Santa Clara Valley Transportation Authority (VTA)  
River Oaks Administrative Offices:  
3331 North First Street  
San Jose, CA 95134  
via mail, Nov. 3, 2014

re: Relocation or elimination of the proposed Alum Rock BART Station

Fig. 1: Berryessa to 28th and 23rd in San Jose

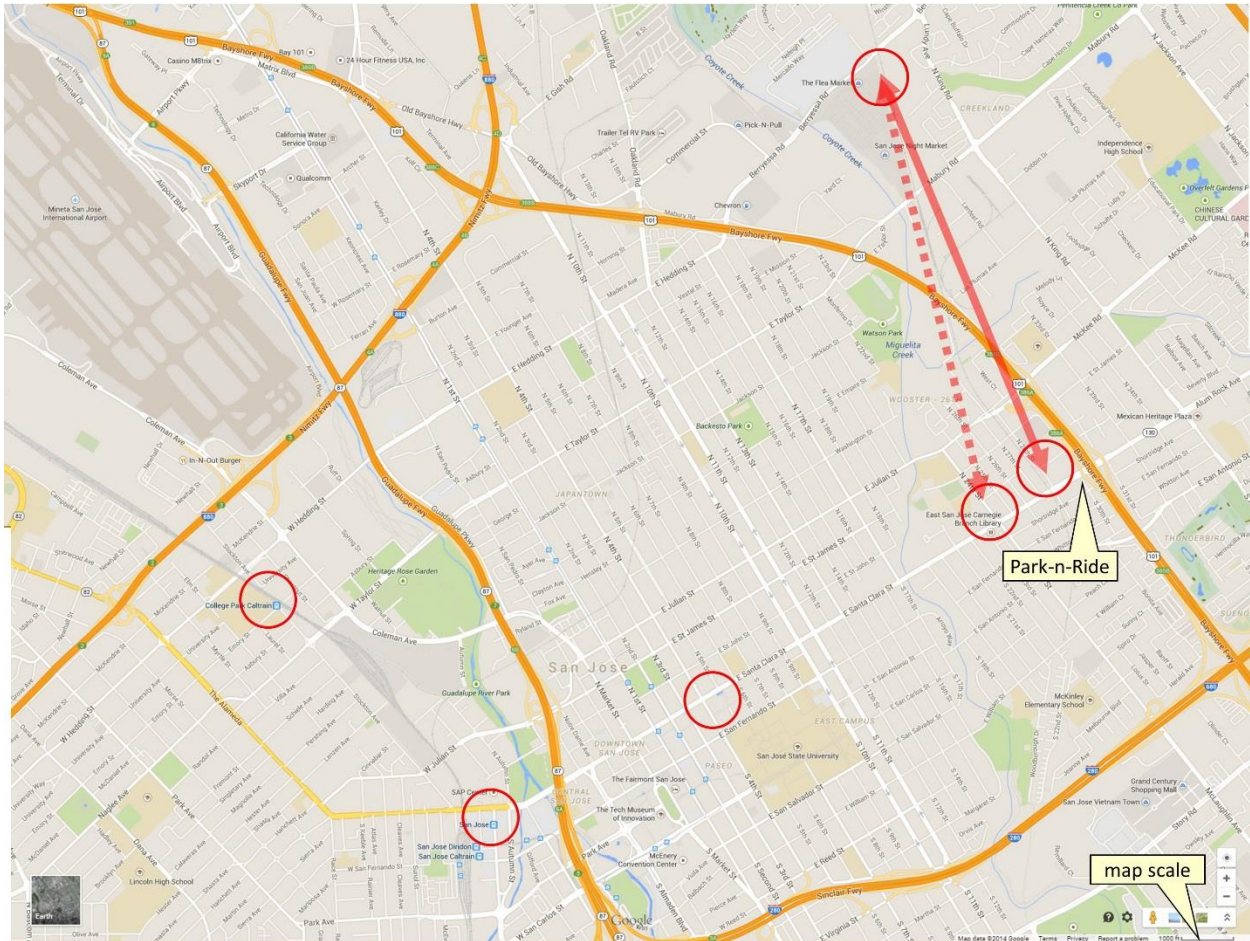
What is the reason for this abrupt change to the Alum Rock Station? Is it because the 28th St. Station is perceived as being too close to the Berryessa Station? If that's the reason, it is spurious: as shown in Fig. 1, the distance from Berryessa to 23rd (dotted line) is virtually the same as the distance to 28th St. And it's a fair distance from there to the next station (Downtown) as well. Furthermore, the Berryessa – 28th separation is not all that small: it is more than the separation between the Embarcadero and Civic Center Stations in San Francisco (see Fig. 2), and there are two other stations (Powell and Montgomery) in between as well!
